Designtex Knitwear Ltd.

16th September 2018

Observations

Discrepancies between drawings and on-site observation

C-5 column

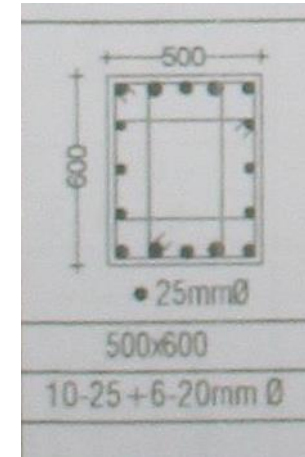
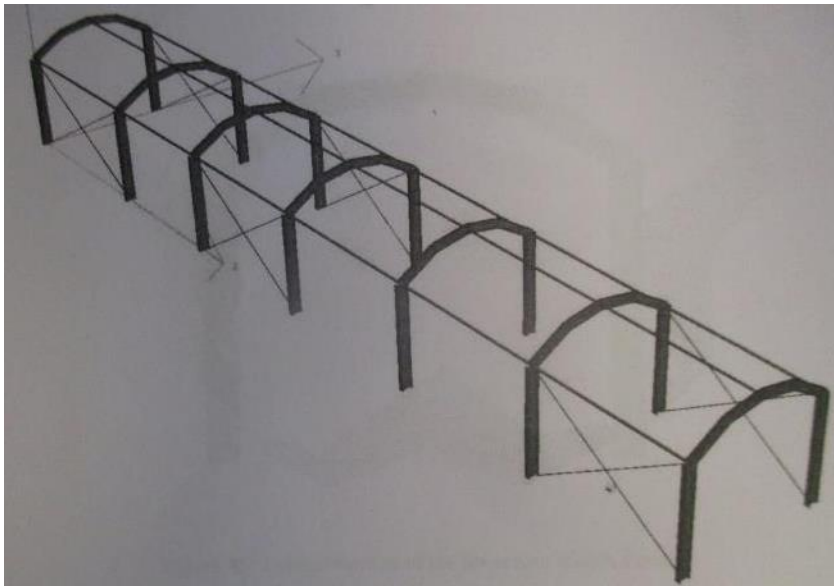
The size of the marked column was found 500mm instead of 600mm as shown in the as-built drawing. The dimension of the column is required to be revised in column schedule and layout.

Arrangement of Vertical cable bracings considered in the design report

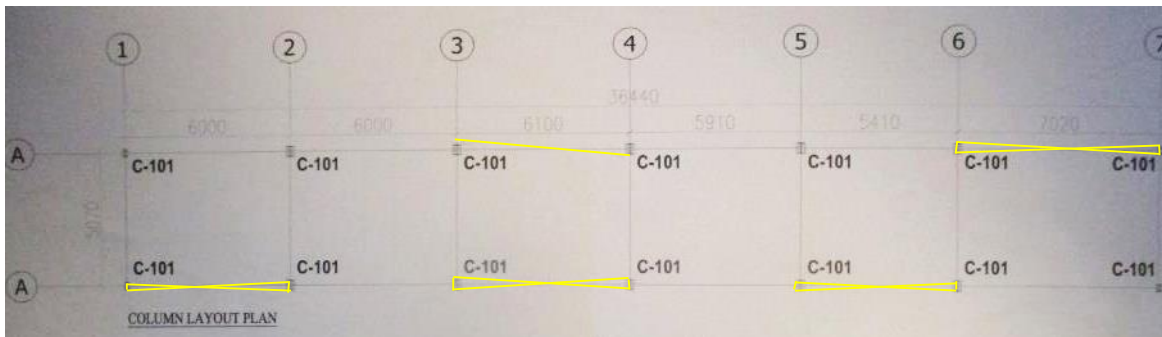
The on-site location of vertical cable bracing did not match with design report. Moreover, no bracing layout was found in the structural drawing. Factory is required to review the design and submit to ACCORD for reviewing.

Expansion joints do not have gap/adequate clearance

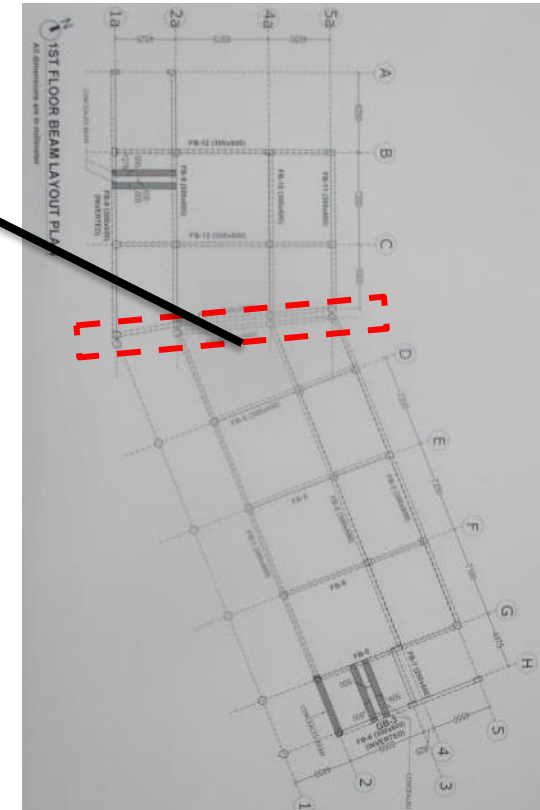
The expansion joints are covered with cement mortar with tiles on top. Clear gap is required to be provided throughout the expansion joint and the gap is to be filled with appropriate materials as per engineer's recommendation.

Item No.	Observation	Recommended Action Plan	Recommended Timeline
7	(Facility Building) Expansion joints do not have gap/adequate clearance	Clear gap is required to be provided throughout the expansion joint and the gap is to be filled with appropriate materials as per engineer's recommendation.	6-weeks
8	(Facility Building) Implement floor load management program	Factory is required to implement load management program (signage, load restriction height marking) as per its floor load plan.	6-weeks
9	(Utility Building) Water ponding on roof	Factory is required to provide proper drainage and other remedial measures to prevent water ponding.	6-weeks
10	(Utility Building) Expansion joints do not have gap/adequate clearance	Clear gap is required to be provided throughout the expansion joint and the gap is to be filled with appropriate materials as per engineer's recommendation.	6-weeks

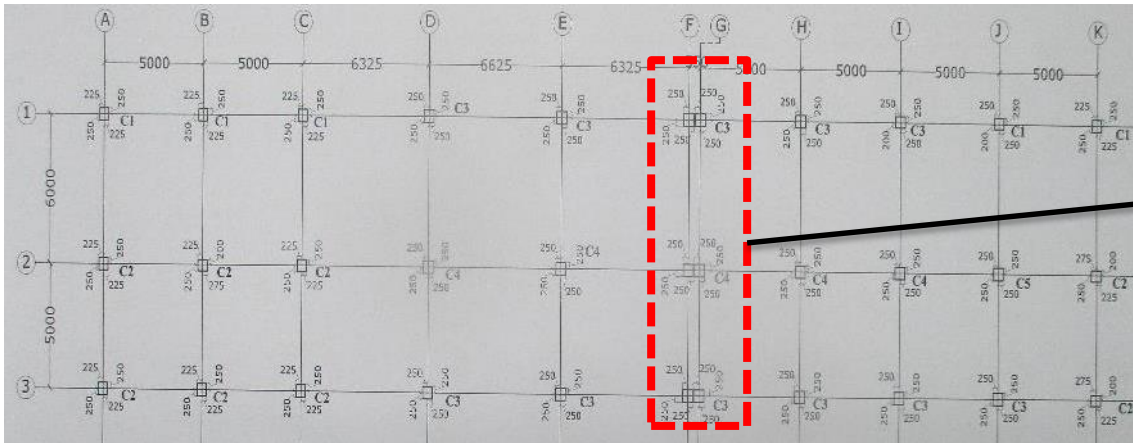
Water ponding was observed under cooling tower on roof. Factory is required to install the proper drainage system.
